ACCESS REPORT

Mixed Use Development

250647 Access Report-r1 SSDA
05 February 2025

Figure 4 | Mark-up of the pedestrian link from the carpark to the building required to be accessible |Source: Smart Studio Design architect B2

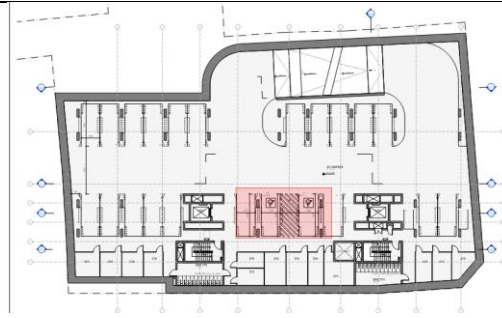
Access to Building Requirements	
DtS Provision	Assessment
<i>D4D3 (1) a)</i> <i>The main points of pedestrian entrance into the site at the allotment boundary;</i>	An accessway into the building from the pedestrian entrance into the site at the southern <i>and</i> western boundary must be provided. The entry location is indicated on the markup below.  Figure 3 Mark-up of the site entrance to the building required to be accessible [Source: Smart Design Studio architect]
<i>D4D3 (1) b)</i> <i>Another accessible building connected by a pedestrian link;</i>	The proposal does not contain a pedestrian link or connection to another building and therefore an assessment against this provision is not applicable.
<i>D4D3 (1) c)</i> <i>Any required accessible carparking space on the allotment.</i>	An accessway into the building from the accessible car spaces located on basement levels B1, B2 and B3 floor of the subject building as marked up below.

Figure 7 | Mark-up of the entrance doors required to be accessible [Source: Smart Studio Design architect]

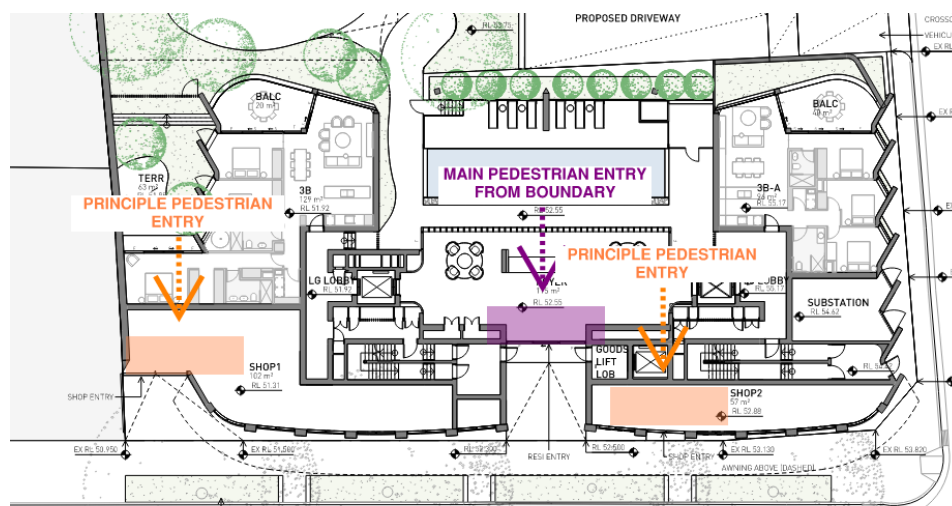
For the purposes of Clause D4D3(2) of the BCA, the following pedestrian doors are required to be accessible:

- Main entry door on the southern façade which adjoins Oxford Street.
- The western entry doorway into the retail tenancy
- The eastern entry doorway into the retail tenancy

Note: Not less than 50% of pedestrian doors are required to be accessible; and as the building contains a floor area of more than 500 m² any entrance which is not accessible cannot be located more than 50 m from an accessible entrance.
